Water coolers model with sparkling water and rotary pump

With a view to continuous improvement, the water coolers with sparkling system and rotary pump will be revised with the following modification:

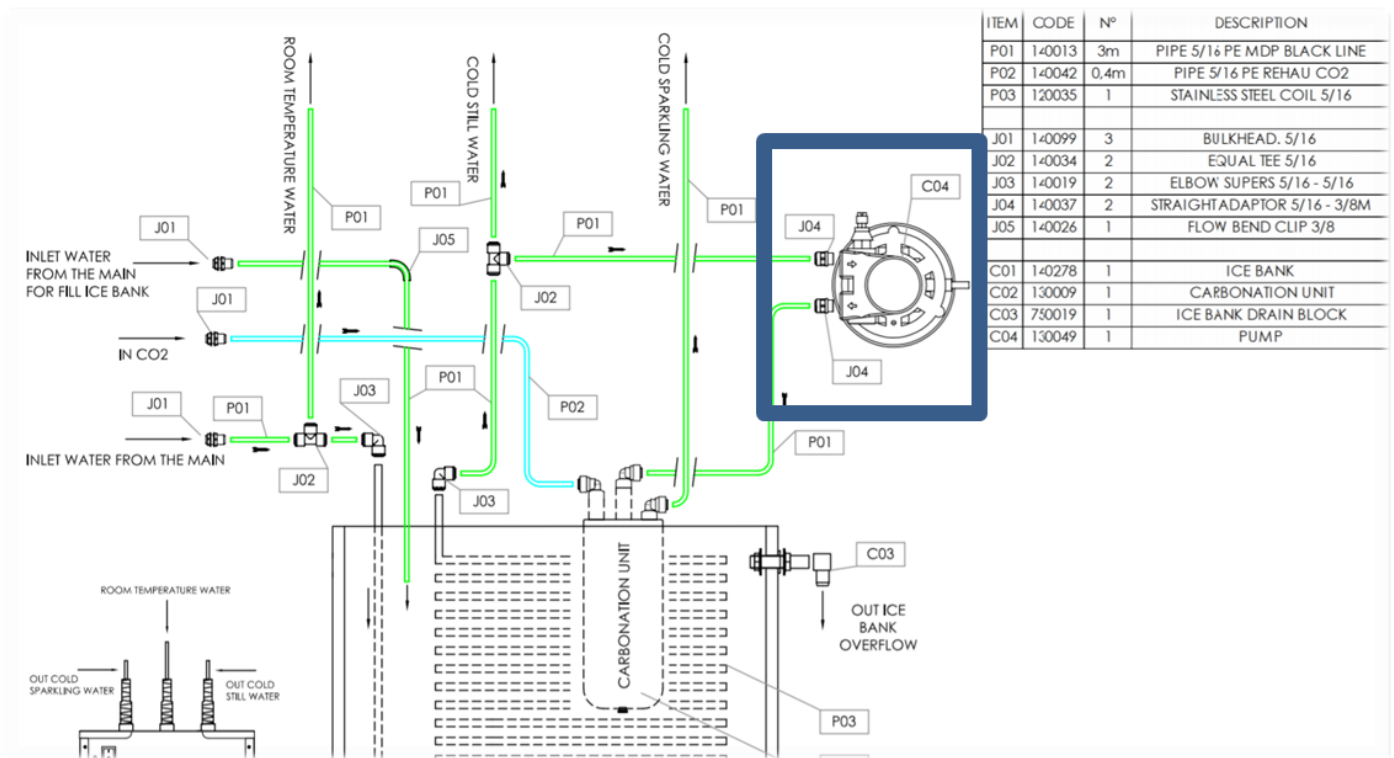
REPLACEMENT OF THE 2 PLASTIC FITTINGS MOUNTED ON THE PUMP HEAD (POS. JO4) WITH METAL FITTINGS (TEA)
